RE: Petition No. 1471 - AT&T Interrogatory Responses

**RESPONSES OF NEW CINGULAR WIRELESS PCS, LLC
d/b/a AT&T TO CONNECTICUT SITING COUNCIL INTERROGATORIES
DATED JANUARY 14, 2022**

SITE NAME: WILLINGTON DALEVILLE ROAD

SITE NUMBER	DRAWING NUMBER	REV
CT1377	C-1	2

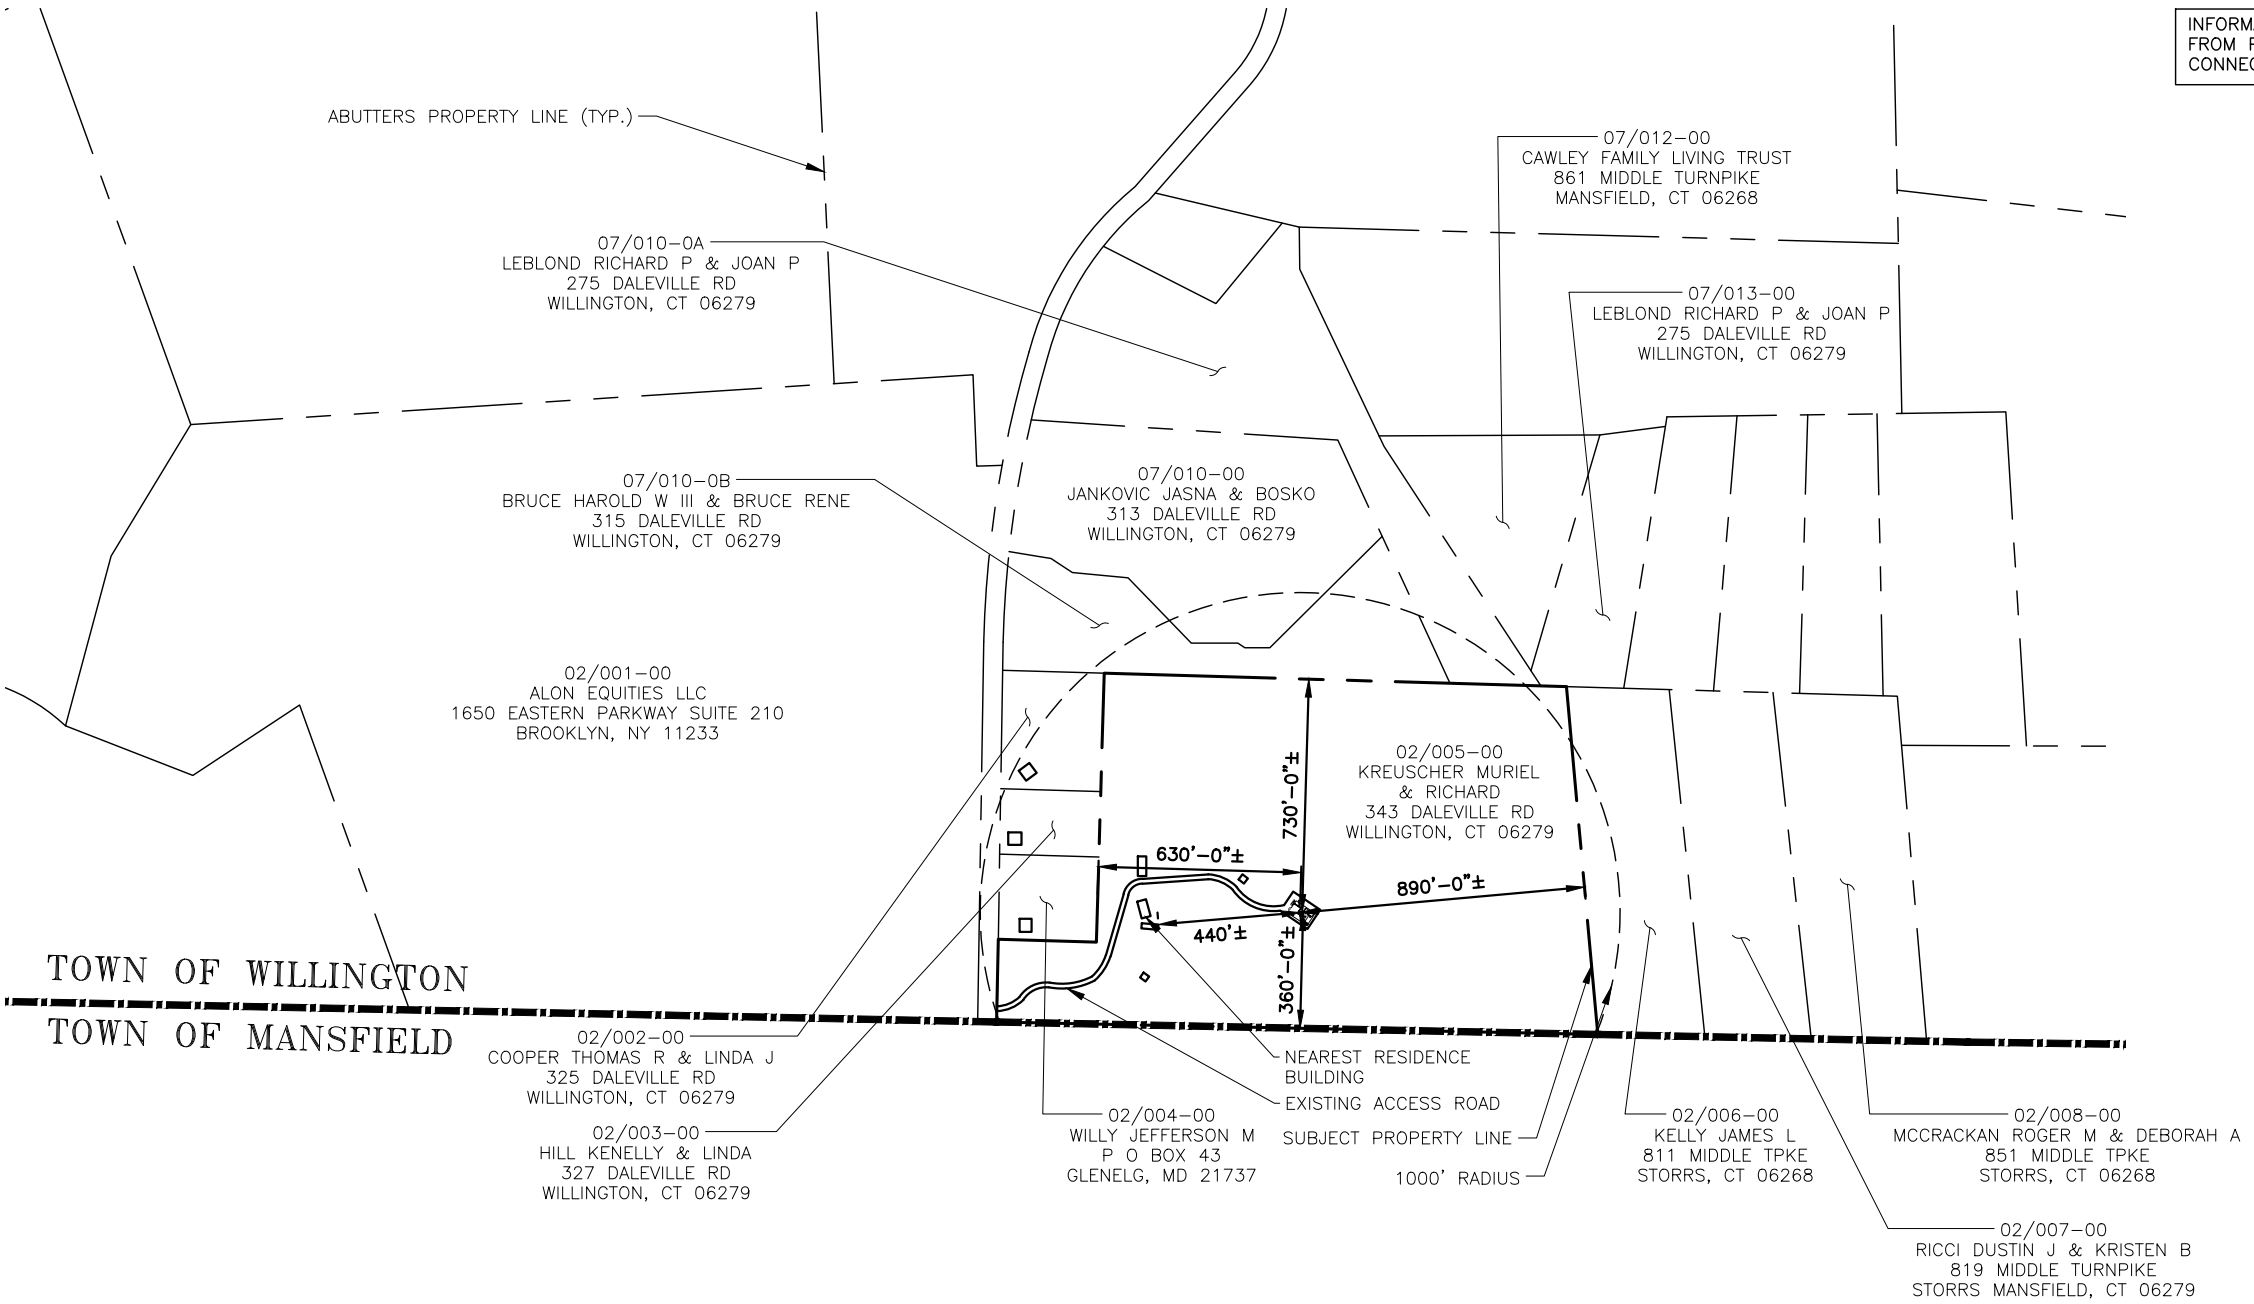
Q2. Petition Attachment 3 - Drawing C-1 General Note No. 9 references site development for erosion and sediment control in accordance with Vermont Department of Environmental Conservation. Clarify the information and provide a revised Drawing C-1.

A2. Please see revised drawings removing the notes on Drawing C-1.
